PARK PLACE ON PEACHTREE

This project scope consists of a new porte cochere to replace the original 1980s era construction, with the intent to utilize the existing below-grade structure as its support and maintain the same approximate footprint. The original slanted glass storefront will be removed and replaced with a new storefront system to match the recently renovated sliding glass entry. The sliding glass entry will be maintained to save costs. The new porte cochere construction consists of a steel moment frame with suspended metal composite

PORTE COCHERE CONSTRUCTION DOCUMENTS

Subject: Revision Narrative – Addendum #1

A200

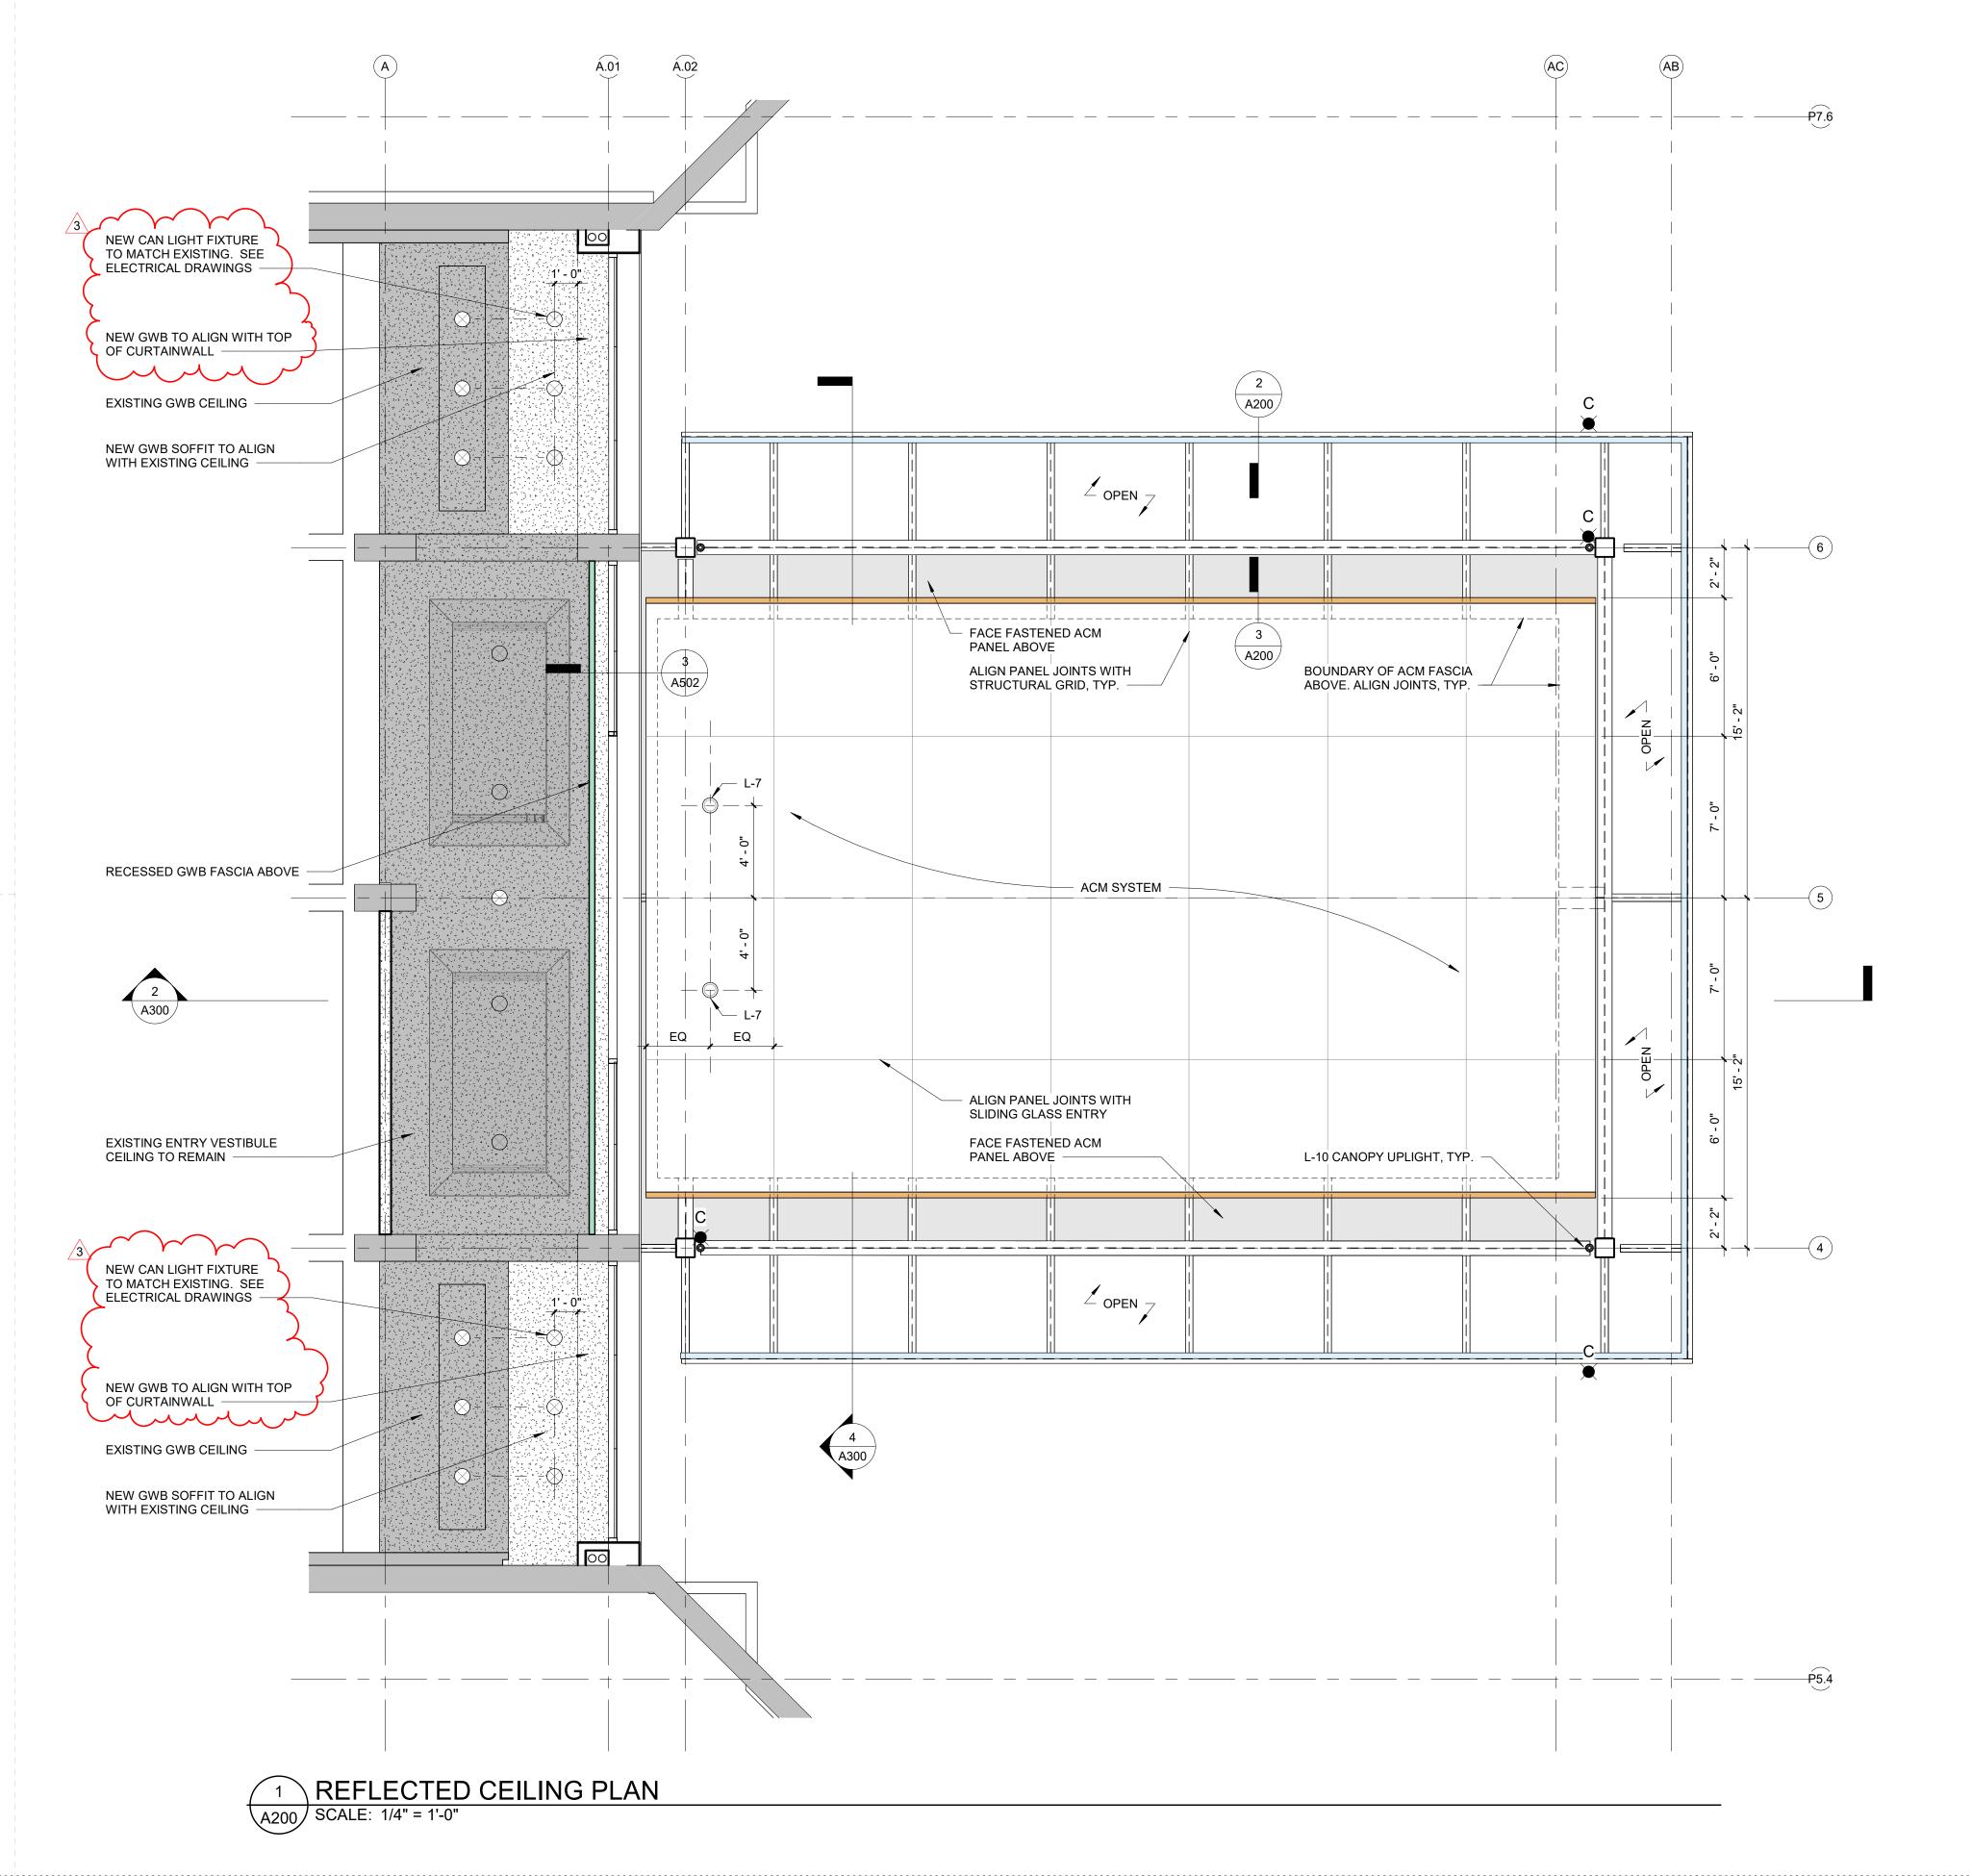
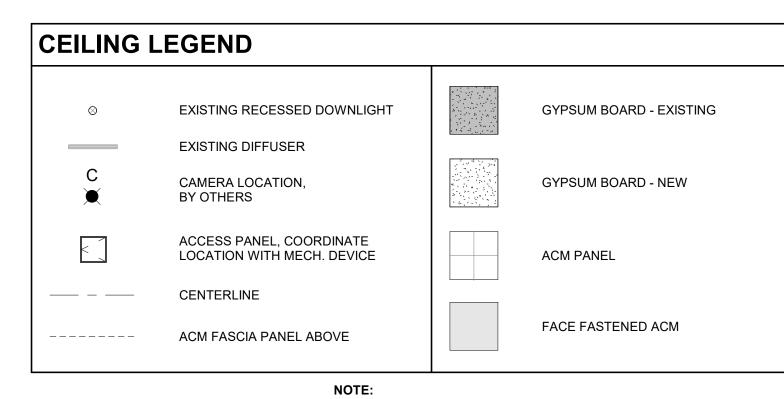
Architectural (Porte Cochere) A000 – Sheet Index - Drawing revision update. A200 – Interior soffit clarification and addition of owner requested light fixtures at lob ceiling. Clarification of L-9 canopy light fixture mounting at ACM. A300 – Addition of owner requested exterior power outlets for holiday wreath A500 - Addition of new owner requested exterior power outlets for holiday wreath. Electrical 	 overs the revisions described below and includes the following sheets (attached). rchitectural (Porte Cochere) A000 – Sheet Index - Drawing revision update. A200 – Interior soffit clarification and addition of owner requested light fixtures at lobby ceiling. Clarification of L-9 canopy light fixture mounting at ACM. A300 – Addition of owner requested exterior power outlets for holiday wreath. A500 - Addition of new owner requested exterior power outlets for holiday wreath. lectrical E202 – Addition of owner requested interior light fixtures at lobby ceiling and 		Bryan Cooke (PPoP)

A200 - Added security camera locations per security coordination.

- Note to provide AESS at all permanently exposed structural steel added per structural coordination comments and RFP RFI responses.

SECTIONS & **ELEVATIONS**

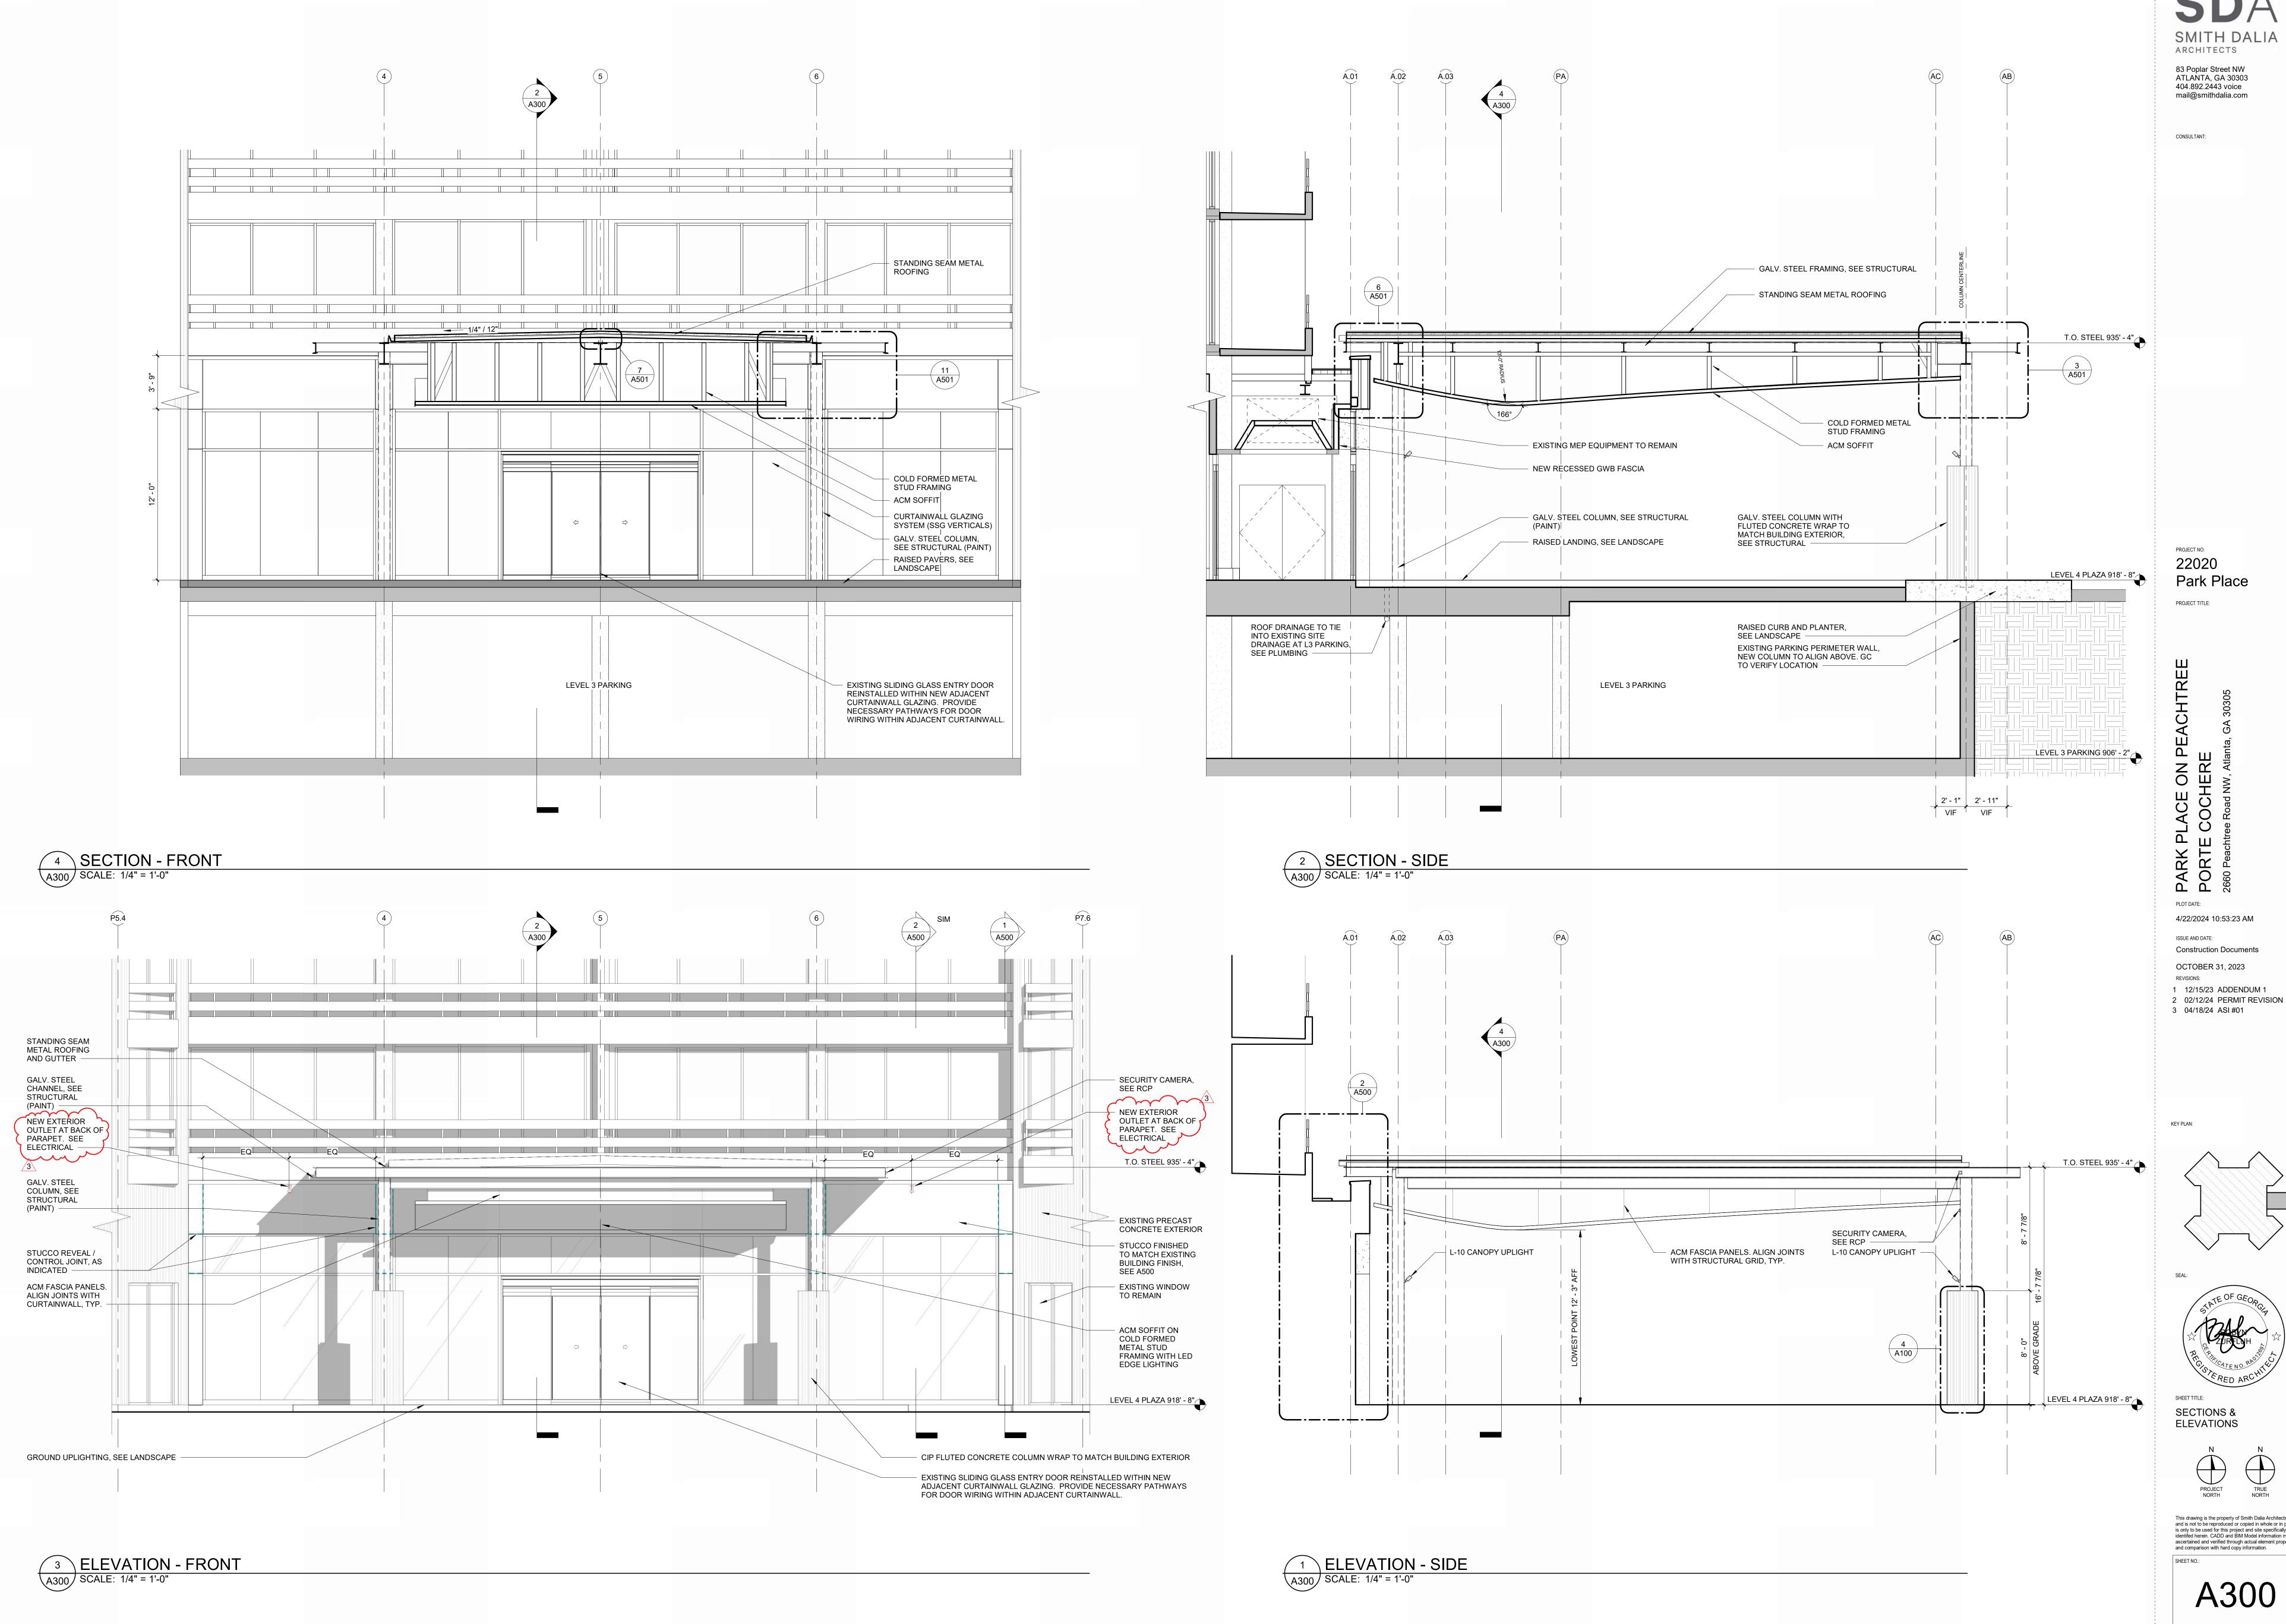
ceiling. Clarification of L-9 canopy light fixture mounting at ACM. A300 – Addition of owner requested exterior power outlets for holiday wreath A500 - Addition of new owner requested exterior power outlets for holiday wreath. Electrical 	 ceiling. Clarification of L-9 canopy light fixture mounting at ACM. A300 – Addition of owner requested exterior power outlets for holiday wreath. A500 - Addition of new owner requested exterior power outlets for holiday wreath. lectrical E202 – Addition of owner requested interior light fixtures at lobby ceiling and 		ctural (Porte Cochere)	_			
 A500 - Addition of new owner requested exterior power outlets for holiday wreath. Electrical 	 A500 - Addition of new owner requested exterior power outlets for holiday wreath. lectrical E202 – Addition of owner requested interior light fixtures at lobby ceiling and 	•					
wreath. Electrical	wreath. lectrical E202 – Addition of owner requested interior light fixtures at lobby ceiling and	•		•	,

A300 - Added security camera locations per security coordination.
